**SUBJECT: ALLEGATIONS PROPOSED DRAFT PLAN
HYDROLOGICAL 2022-2027.
CYCLE 2022-2027**

TO THE HYDROGRAPHIC CONFEDERATION OF SEGURA

Figura 3-13. Plano de calados para la Rambla de El Albuñón y la Rambla de Miranda. SNCZI

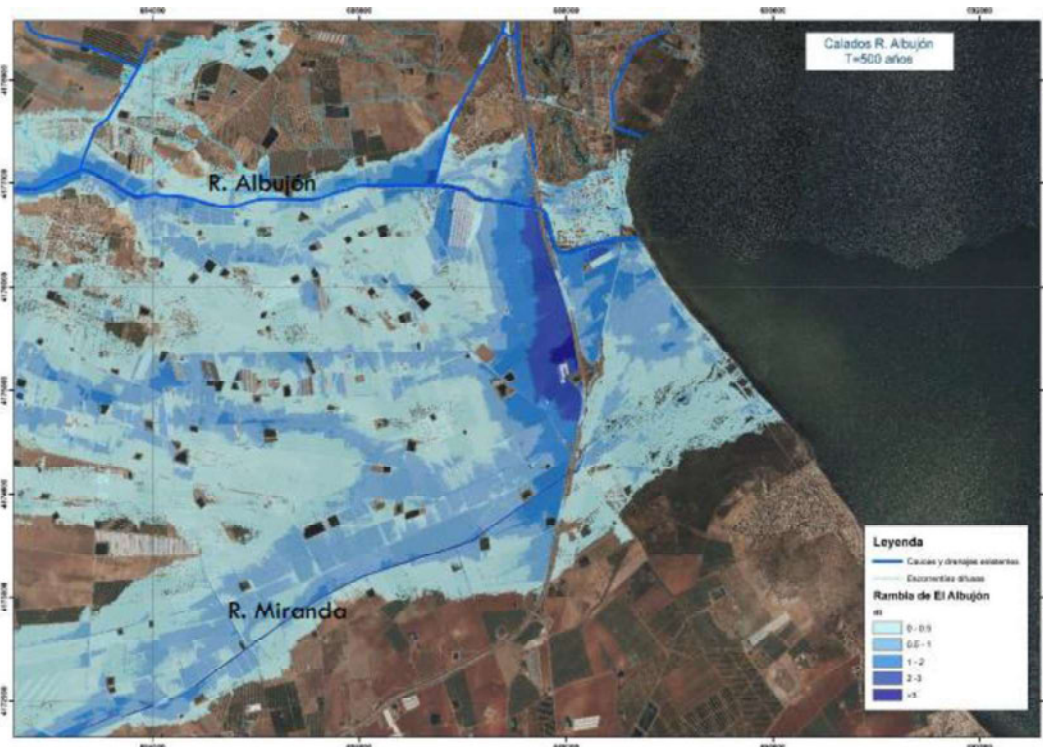
Como puede verse en la imagen anterior, se observa claramente el efecto de retención que genera el talud de la autopista AP7 sobre el flujo desbordado de la Rambla de El Albuñón y la Rambla de Miranda (más al sur). Este efecto de almacenamiento en la zona donde desagua el D7 alcanza calados superiores a los 2 m para el periodo de retorno de 500 años.

Due to the foregoing, it is not possible to understand that, apparently, the increase in flooding is not contemplated in any of the cases due to the effect that the AP-7 slope generates on the houses upstream of it.
